## TECHNICAL NOTE

File Ref: PZ/VL/P21-2329/01TN

Subject: **Fordley Hall – Deadline 6 Submission Noise**

**FORDLEY HALL – SIZEWELL C LINK ROAD**  
**Construction And Operational Noise Assessment**

**Chart 5.1: Noise Monitor Results**

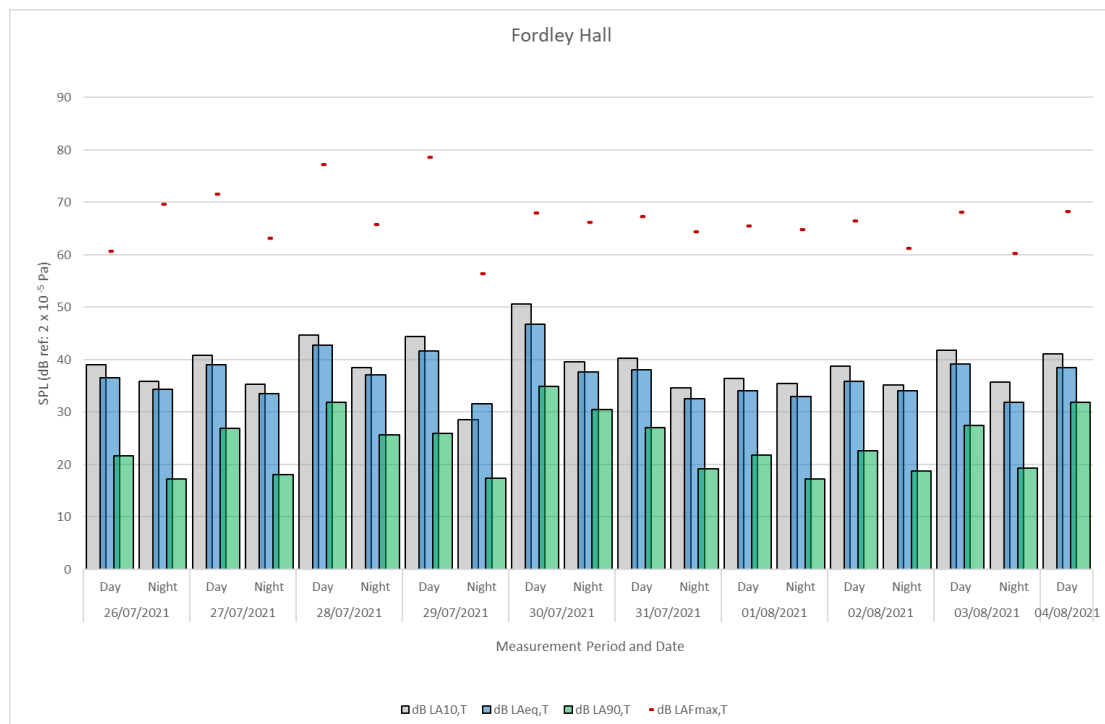
- 5.3 As can be seen in the table and chart above, the ambient levels remained very low, which is expected for this largely rural location. The most commonly occurring daytime ambient sound level at this location was  $\approx 38\text{--}39$  dB  $L_{Aeq,1hr}$  and the daytime background sound level ranged between 22 and 35 dB  $L_{A90,Day\ Time}$ . The night time background sound levels were far lower, between 17 and 27 dB  $L_{A90,Night(8\ hours)}$ , but with a most commonly occurring background sound level of 17 dB  $L_{A90,1hr}$ .

**Figure 5.1: Measurement Location** Excerpt from Book 6, Volume 6, Chapter 4, Figure 4.2

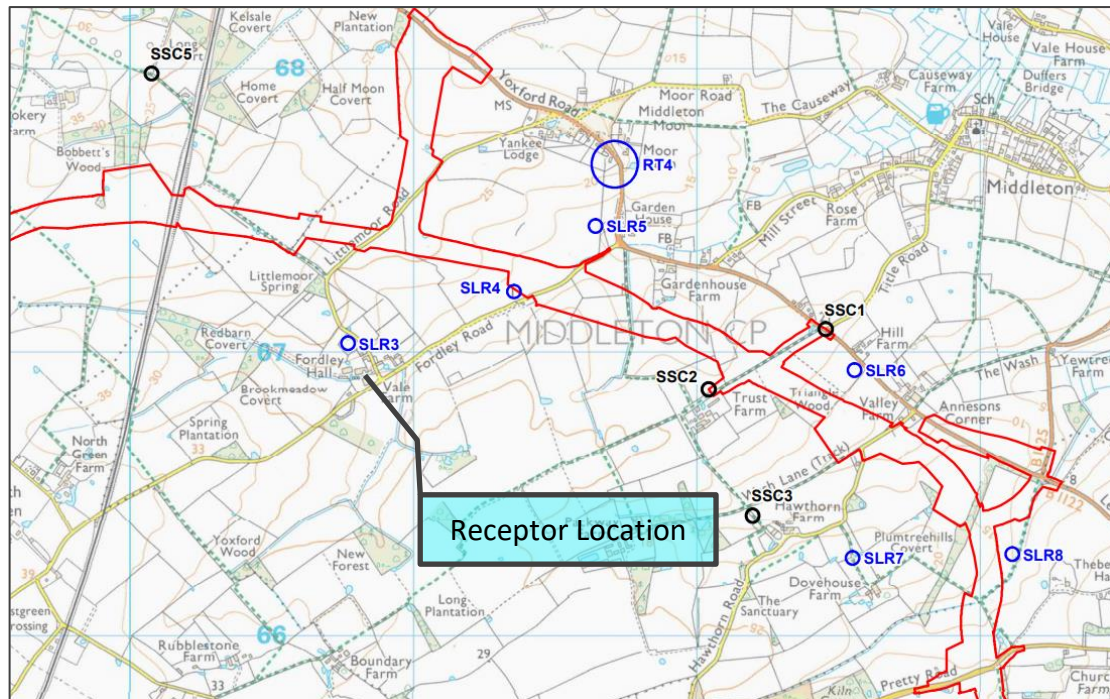
- 5.4 The most representative monitor location in the EDF ES for the Fordley Hall residence NSR would be SLR 3, which was stated to be a typical measured daytime level of 45–47 dB  $L_{Aeq,T}$ . (Table 4.13, Book 6, Volume 6, Chapter 4). A detailed analysis of the measured sound levels was included within Book 6, ES Volume 2, Chapter 11, the Noise and Vibration Baseline Report.
- 5.5 Within the submitted document, the baseline sound levels were in 6–8 dB excess to those from the Create baseline sound monitoring for the daytime, and the background sound levels were significantly higher.
- 5.6 Presumably the considerable difference was due to the reliance on two individual thirty minute measurements during the day and a single one hundred and twenty minute measurement at night time.
